PLAZA NATIONAL BANK

AMENDED SITE DEVELOPMENT PLAN

Z-76-172.4

PROJECT: CONVENIENCE STORE, CARWASH + GAS PUMPS FOR ROBERTS OIL CO.

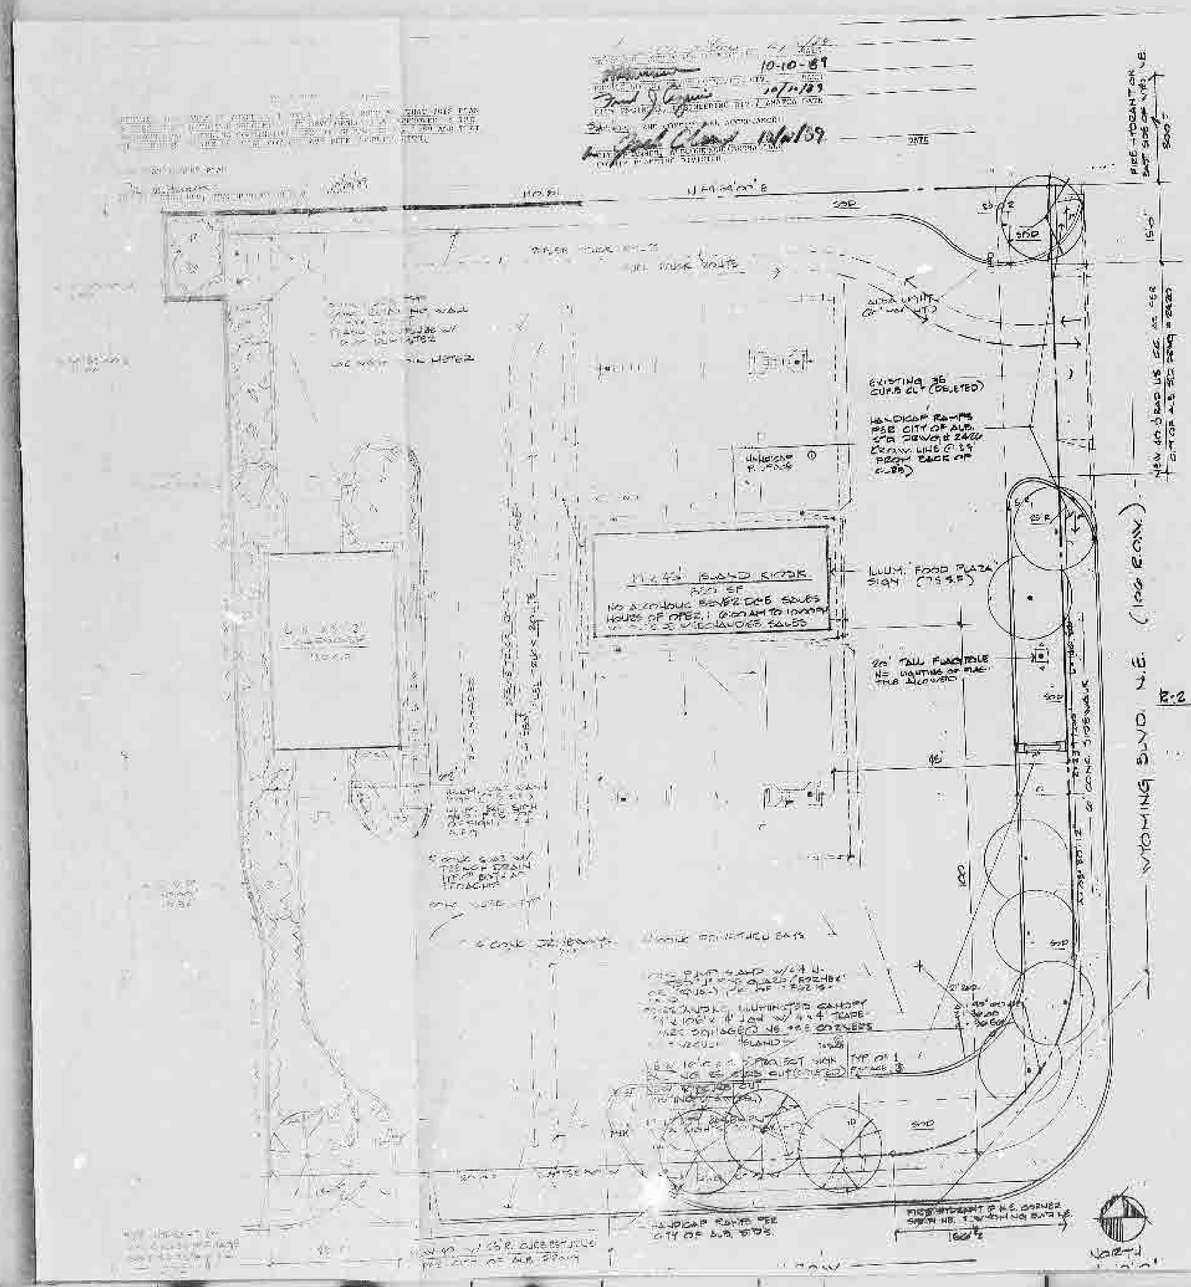
CHANGES TO ORIGINAL:

1. REMOVE OFFICE BLDG + DRIVETHRU CANOPY FOR REPLACEMENT BY 850 SF CONVENIENCE STORE, 914 SF CARWASH + RR 6, & 2 NPD PUMP SERVICE STA W/ CANOPY
2. ADD 2'-0" FILL TO NORTHERN PORTION OF SITE
3. INSTALL CONCRETE RETAINING WALL @ WEST PL + PORTION OF NORTH PL
4. ADD STREET TREES ALONG WYOMING ST. + SPAIN ST.
5. ENLARGE WYOMING 36' CURB CUT TO 40' RADIUS CURB CUT
6. DELETE 36' CURB CUT @ SPAIN NE.
7. ADD 40' RADIUSED CURB CUT @ SPAIN NE.
